Rattle Noise from Automatic Transmission Control Cable Assembly in Reverse

YEAR(S)	MODEL(S)	ADDITIONAL INFORMATION
2007 – 2009	Yaris	Transmission(s): 4AT

TSB SUPERSESSION NOTICE

The information contained in this TSB supersedes TSB No. TC005-07.

Figure 1.

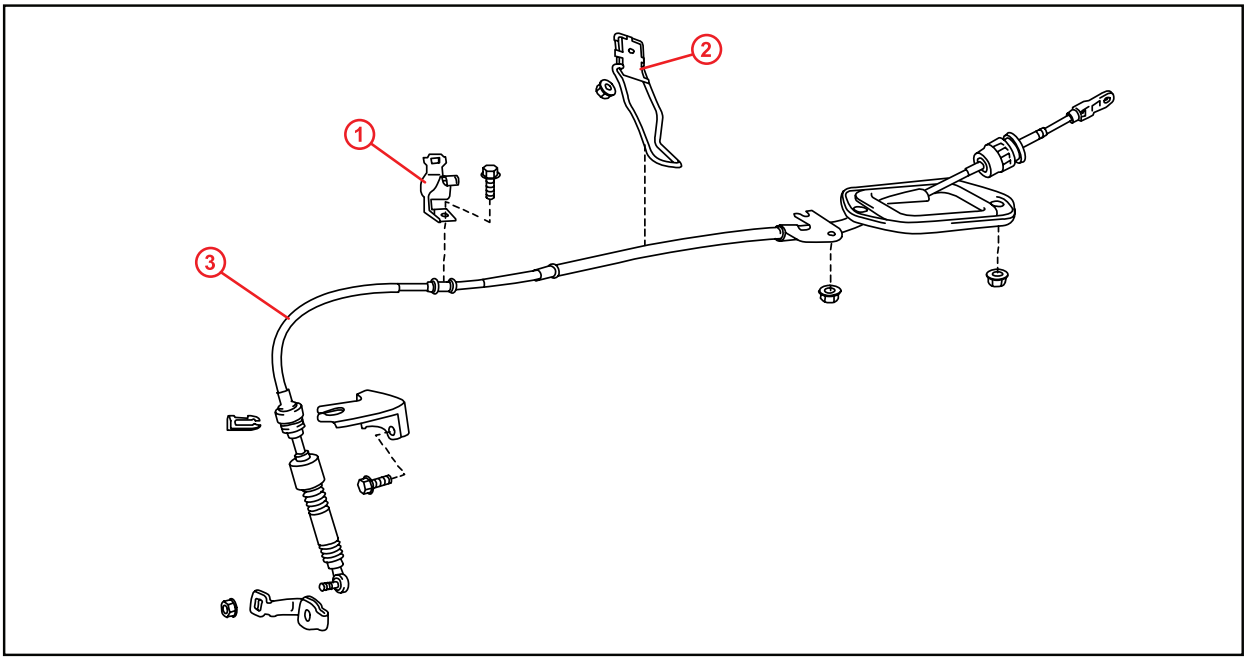
Some 2007 – 2009 model year Yaris vehicles may exhibit a rattle noise from the engine compartment with engine speed above idle and the automatic transmission shift lever position in reverse. Follow the repair procedure below to address this condition.

1. Raise the vehicle and locate the No. 2 transmission control cable support to the left of the center exhaust pipe flange.
2. Using the plastic clamp, secure the automatic transmission control cable assembly to the No. 2 transmission control cable support. Refer to Figure 1 for the location.
